DESIGN REVIEW REPORT AND DECISION

File Number: DSRFY2026 - 0016

Review Status: INITIAL REVIEW- NOT APPROVED

Applicant: Tony Thurber with Anchored Architects

Figure 1. Original Town Circulation Network Acquisition Plan

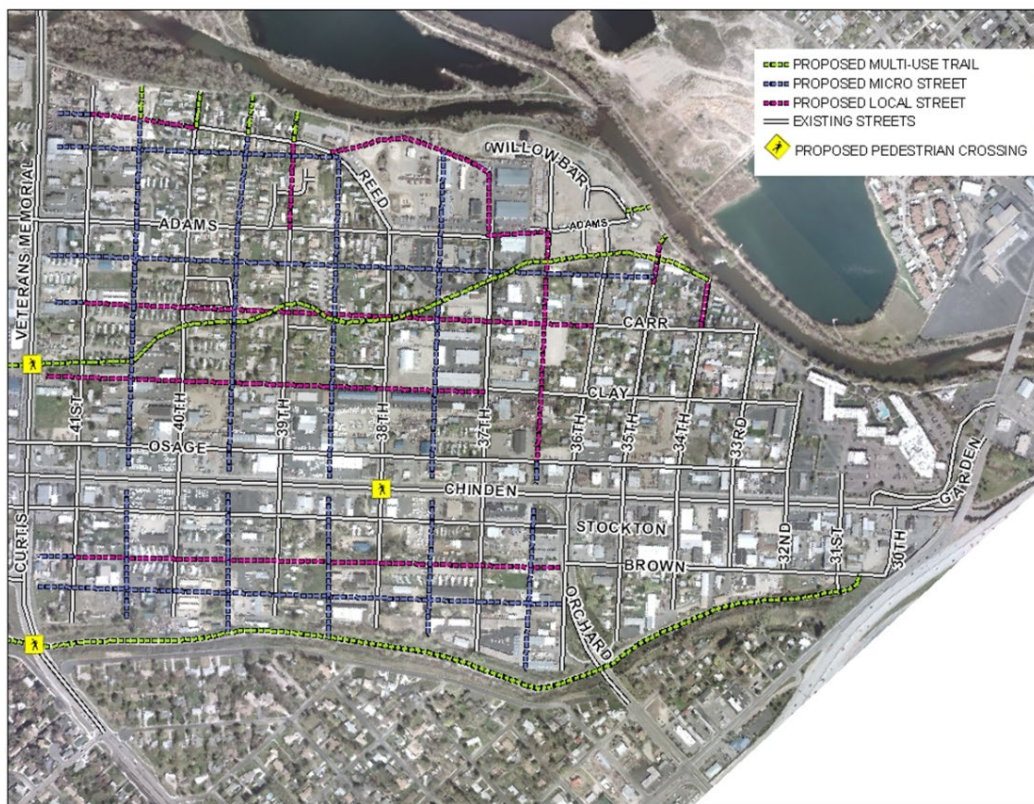
As shown on the adopted circulation map, both planned facilities traverse the subject site and are intended to serve as part of a broader neighborhood connectivity network linking residential areas, destinations, and the Boise River Greenbelt. The proposed development does not provide these planned connections and does not identify easements, setbacks, or other mechanisms that would preserve the opportunity for their future implementation.

Findings 2 and 3 require that the proposed design provide effective bicycle and pedestrian access and movement to, from, within, and across the site and that the design be compatible with or improve **the public's use of existing and planned public spaces** and transportation facilities. Because adopted planning documents identify future bicycle and pedestrian connections through the site, the applicant should demonstrate how the proposed development accommodates, preserves, or supports those planned connections.

The proposal replaces an existing single-family residence with a 24-unit multifamily development within the R-3 (Medium Density Residential) zoning district and an identified activity node. While increased residential density is generally consistent with the purpose of the district, such development should also support the transportation and connectivity framework envisioned for the area. Preservation of planned bicycle and pedestrian corridors is particularly important where higher-density residential development is proposed within locations identified for future multimodal connections.

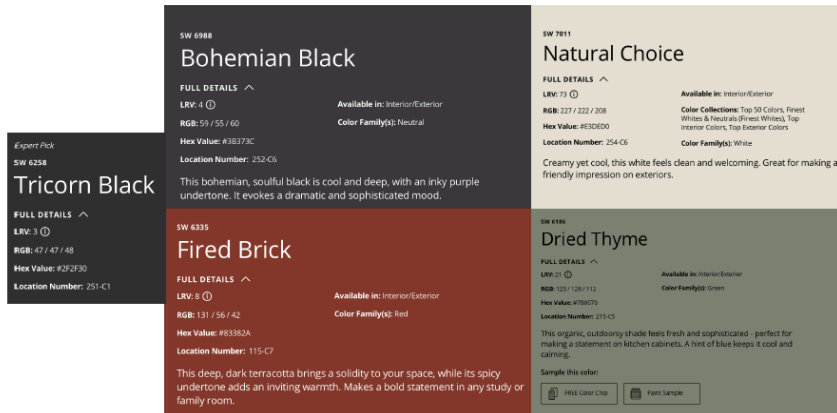
Objective 3: Buildings shall be designed and constructed of quality materials.

Figure 2. Riverplace Subdivision Pedestrian and Bicycle Easement

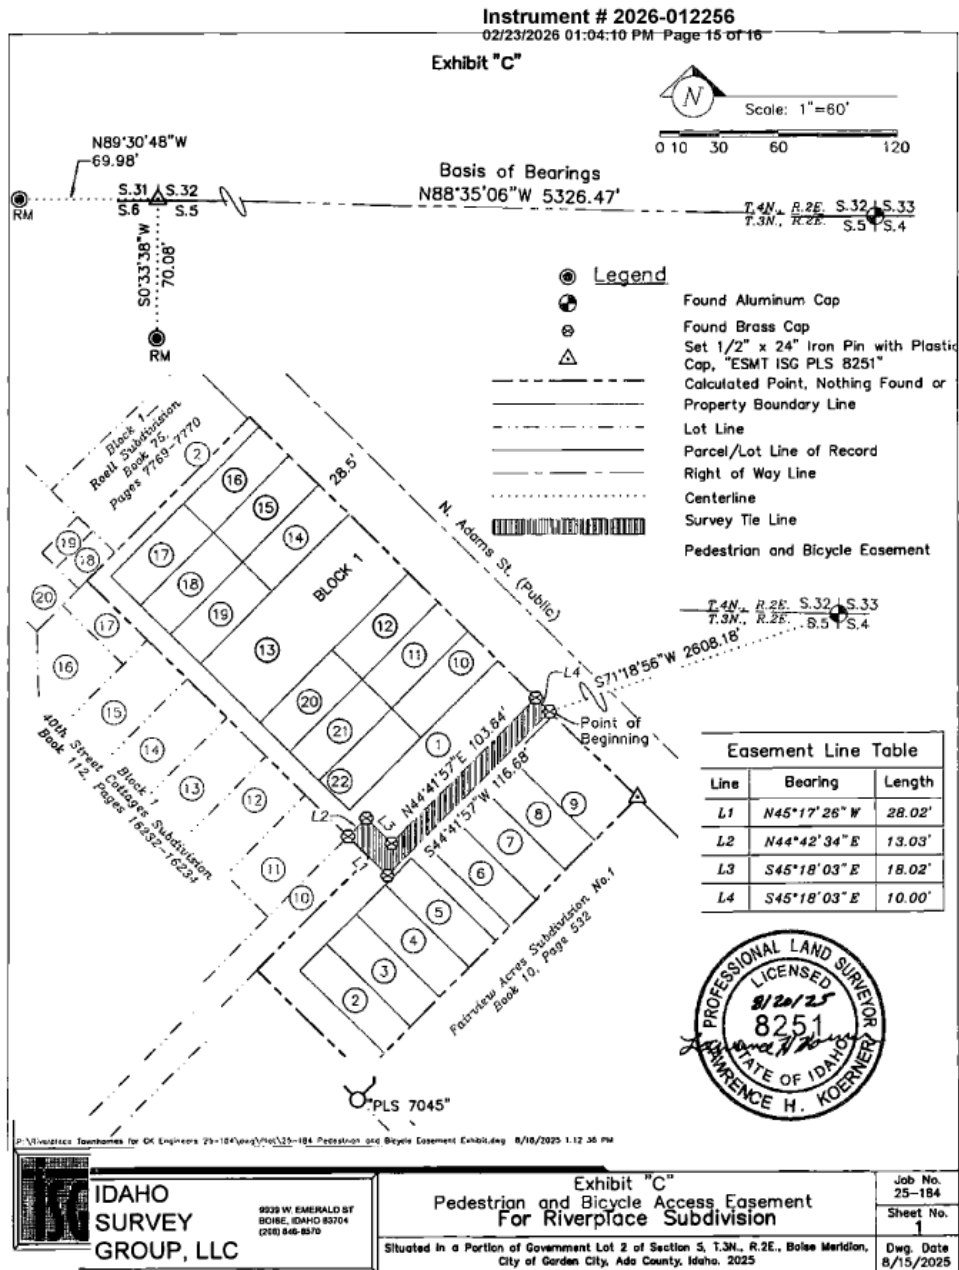
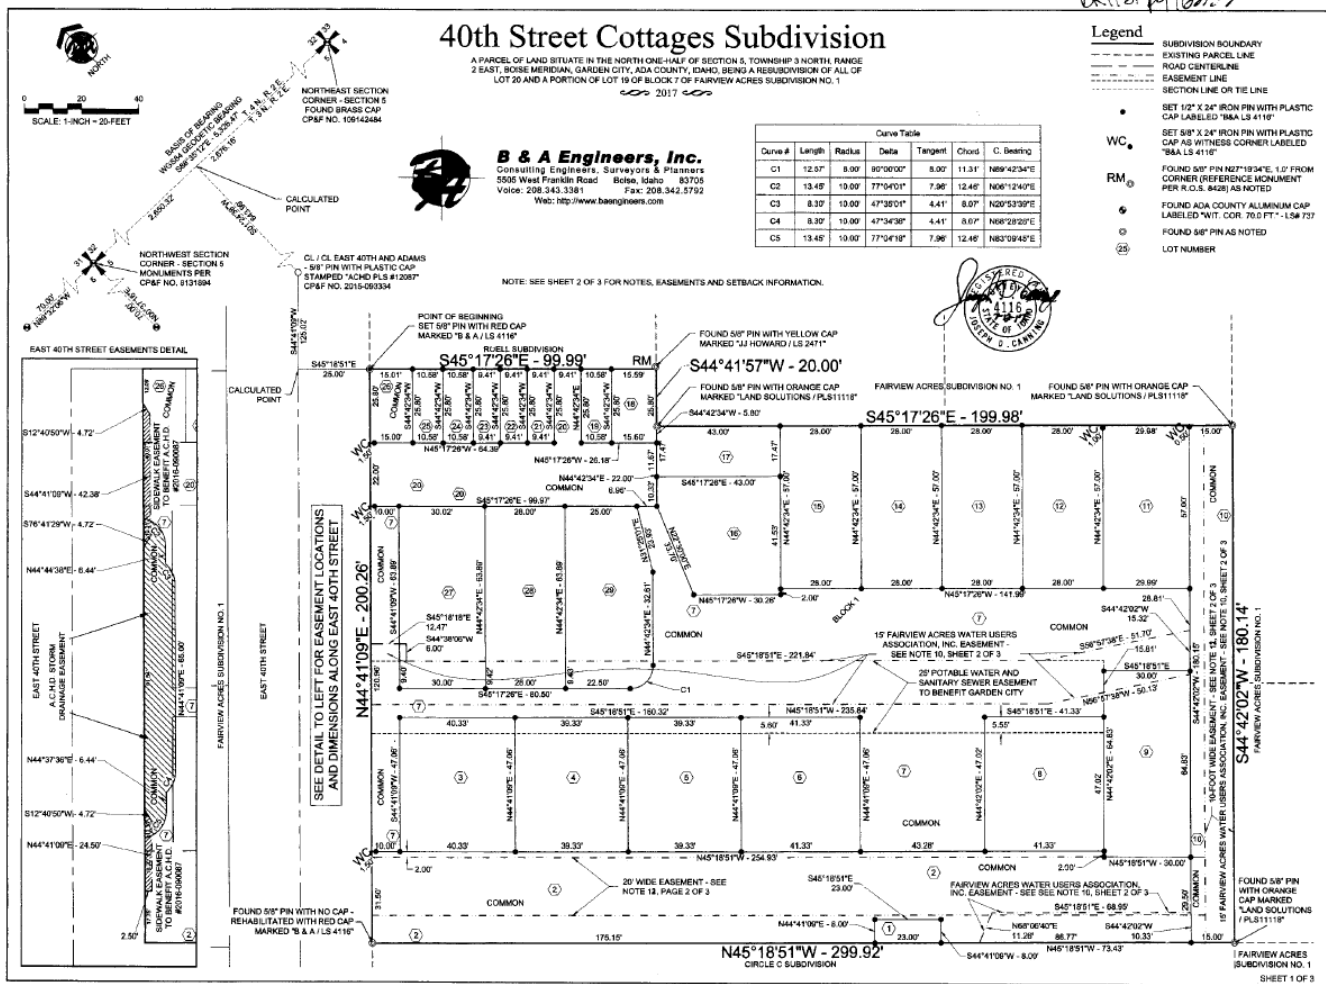
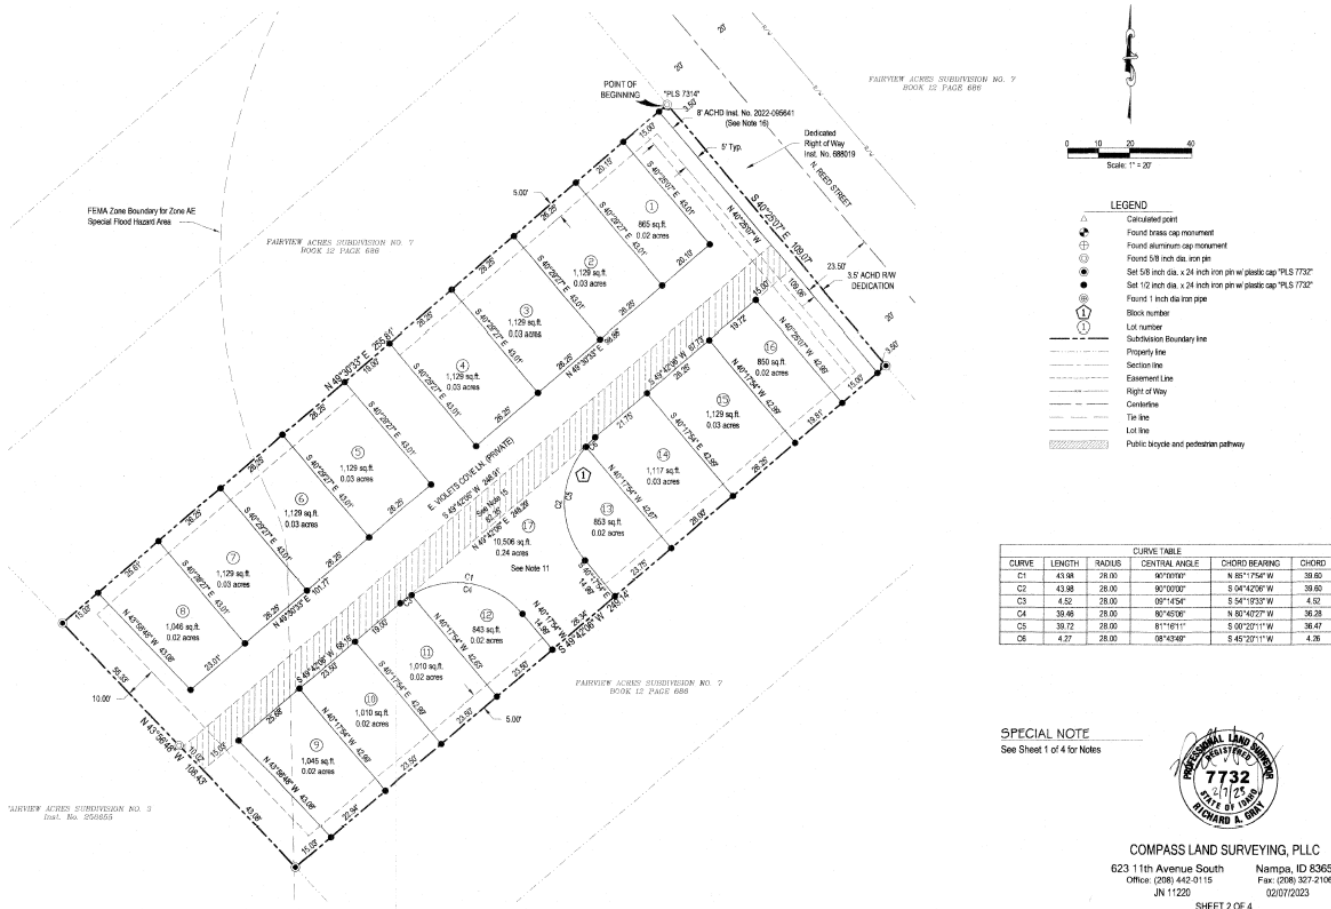
Several developments within the surrounding area have recorded easements or otherwise preserved corridors to facilitate implementation of the planned connectivity network, as shown in [Figures 2–4](#). The proposal does not appear to preserve or otherwise accommodate the planned pathway connection identified in adopted plans. As a result, staff finds limited evidence that the proposal supports the long-term bicycle and pedestrian network or fully satisfies Findings 2 and 3.
